PG&E Letter DCL-18-100

Diablo Canyon Units 1 and 2
Docket No. 50-275, OL-DPR-80
Docket No. 50-323, OL-DPR-82
License Amendment Request 18-02
License Amendment Request to Revise Technical Specification 5.6.5b, "Core Operating Limits Report (COLR)" for Full Spectrum Loss-of-Coolant Accident Methodology

License Amendment Request 18-02, License Amendment Request to Revise Technical Specification 5.6.5b, "Core Operating Limits Report (COLR)" for Full Spectrum Loss-of-Coolant Accident Methodology

FSAR UPDATE
UNITS 1 AND 2 DIABLO CANYON SITE
FIGURE 15.1-6 RESIDUAL DECAY HEAT (BEST ESTIMATE LBLOCA 1979 ANS DECAY HEAT)

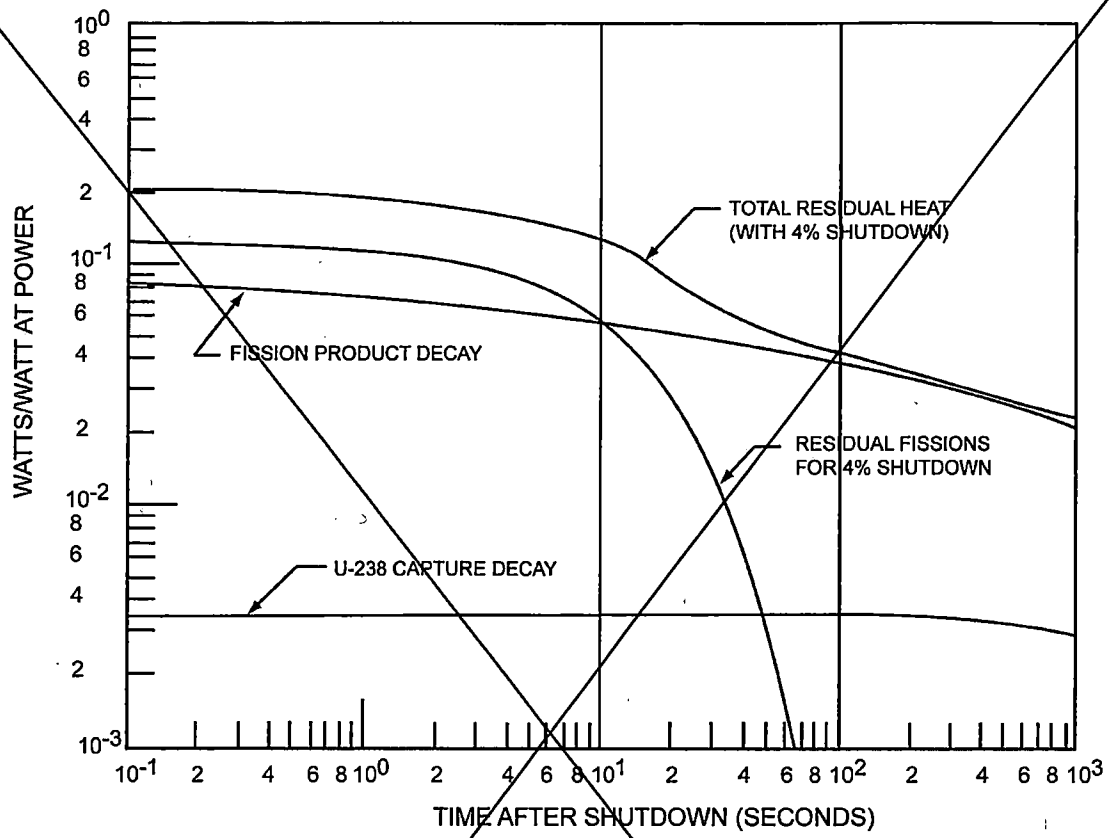
~~For the purpose of illustration, only one delayed neutron group calculation, with a constant shutdown reactivity of -4 percent~~ ~~Δk~~ ~~is shown in Figure 15.1-6.~~

Delete Figure 15.1-6
